Airworthiness Directive

AD 64-09-05

Airworthiness Directives; Piper Model PA-30 Aircraft
PDF Copy (If Available):

Figure 1

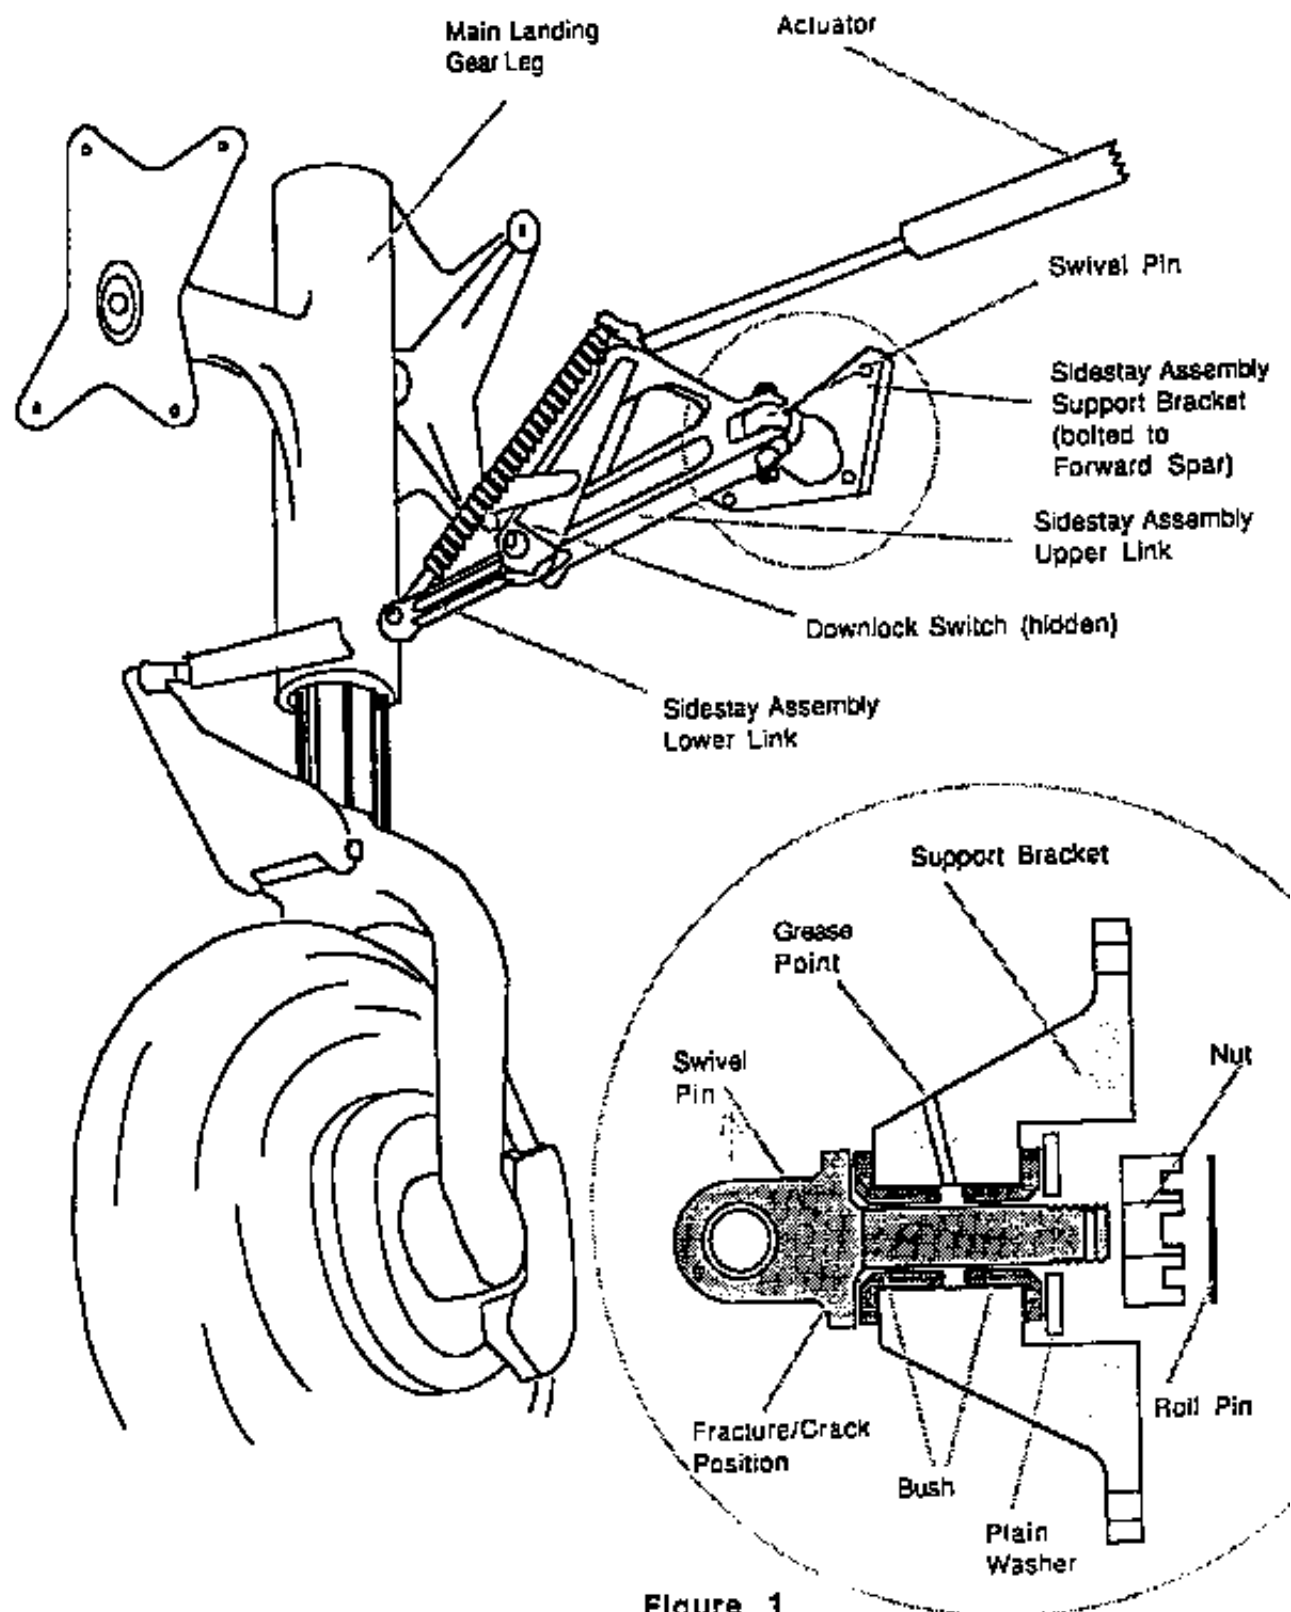
The main gear sidebrace studs on these airplanes will require removal to determine the P/N installed.

the 5/8-inch diameter main gear sidebrace stud, P/N 78717-02.

- The embossed number of 95363 on the bracket forging is not the bracket assembly P/N.
- The bracket assemblies identified with casting number 67073-2 or 67073-3 contain a 9/16-inch diameter main gear sidebrace stud, P/N 67543, and two-piece bushing, P/N 67026-2 and 67026-3.
- Model PA-28R-180 airplanes, serial numbers 28R-30004 through 28R-31270; and Model PA-28R-200 airplanes, serial numbers 28R-35001 through 28R-35820 and 28R-7135001 through 28R-7135062, are equipped from the factory with bracket assemblies identified with casting number 67073-2 and 67073-3.
- P/N 67543 main gear sidebrace studs are 9/16-inch in diameter.

Figure 1

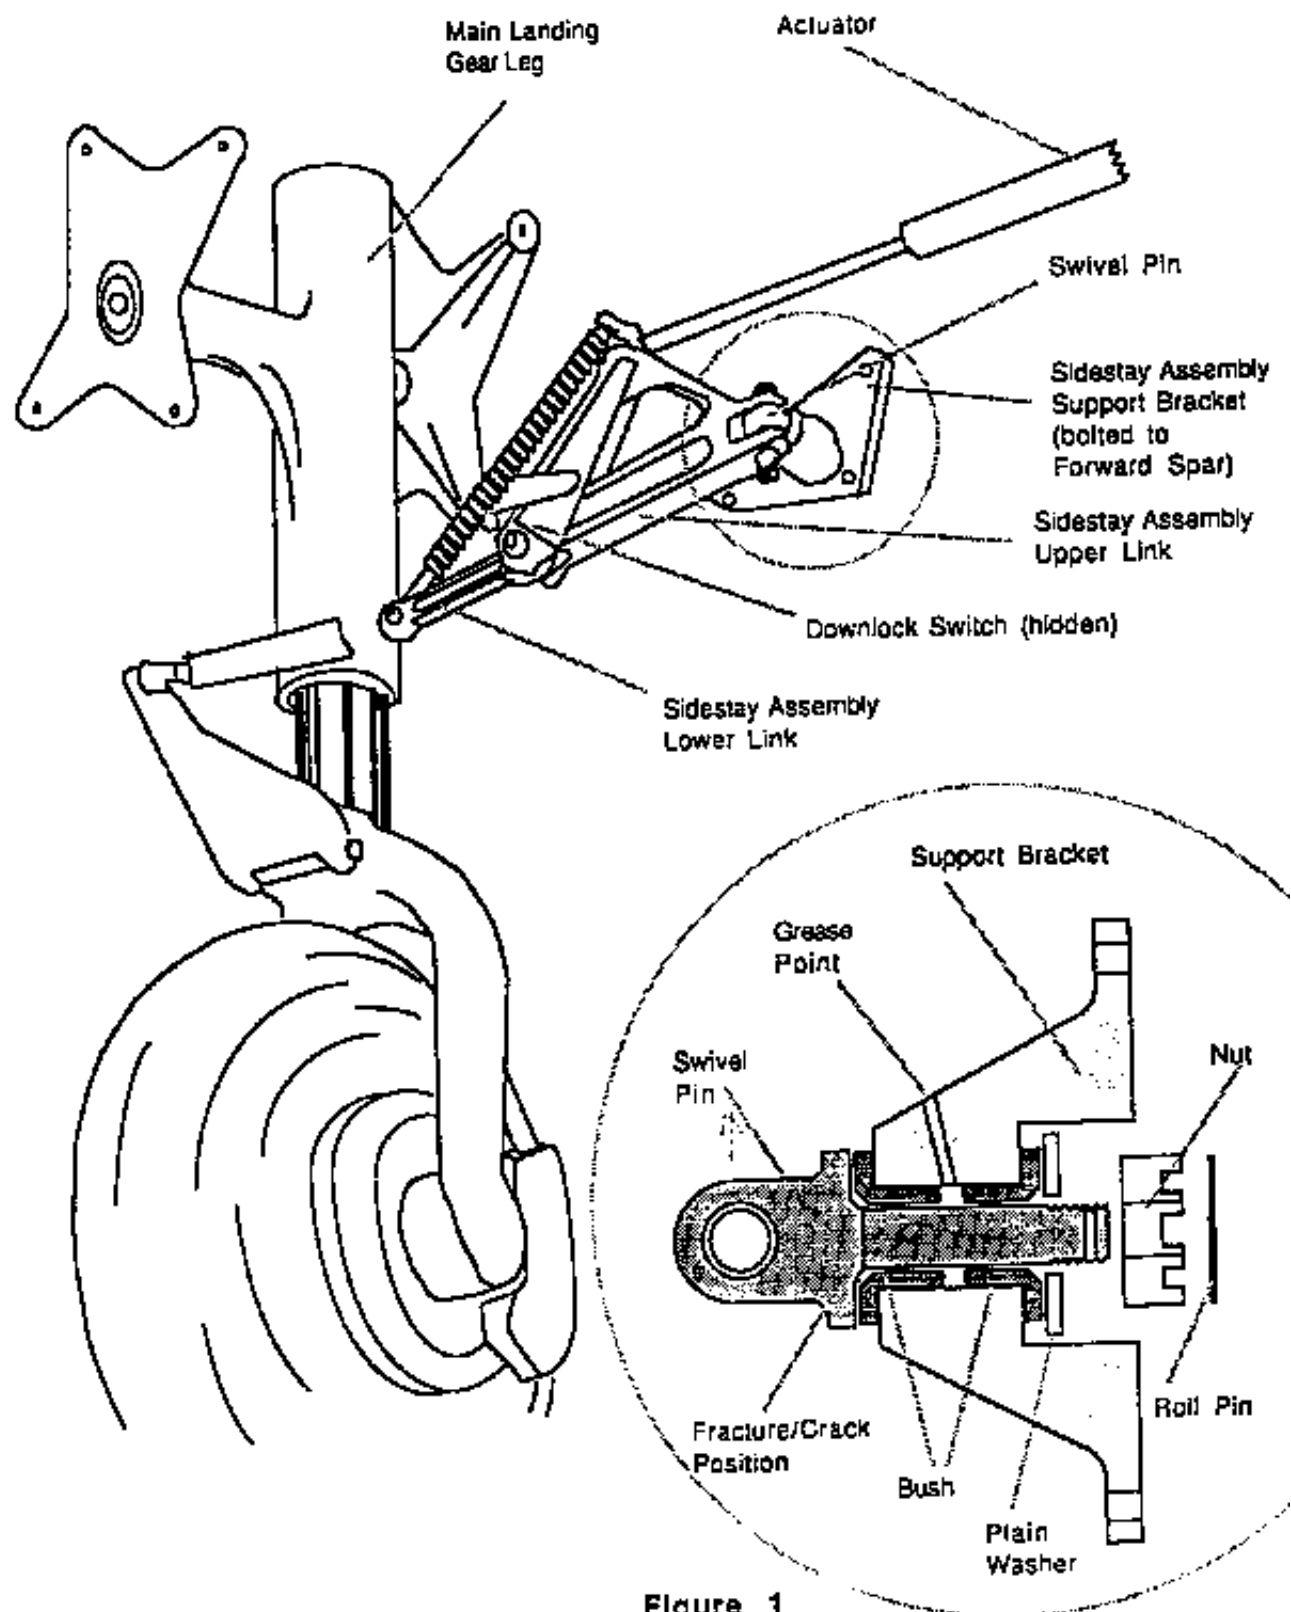
The main gear sidebrace studs on these airplanes will require removal to determine the P/N installed.

the 5/8-inch diameter main gear sidebrace stud, P/N 78717-02.

- The embossed number of 95363 on the bracket forging is not the bracket assembly P/N.
- The bracket assemblies identified with casting number 67073-2 or 67073-3 contain a 9/16-inch diameter main gear sidebrace stud, P/N 67543, and two-piece bushing, P/N 67026-2 and 67026-3.
- Model PA-28R-180 airplanes, serial numbers 28R-30004 through 28R-31270; and Model PA-28R-200 airplanes, serial numbers 28R-35001 through 28R-35820 and 28R-7135001 through 28R-7135062, are equipped from the factory with bracket assemblies identified with casting number 67073-2 and 67073-3.
- P/N 67543 main gear sidebrace studs are 9/16-inch in diameter.
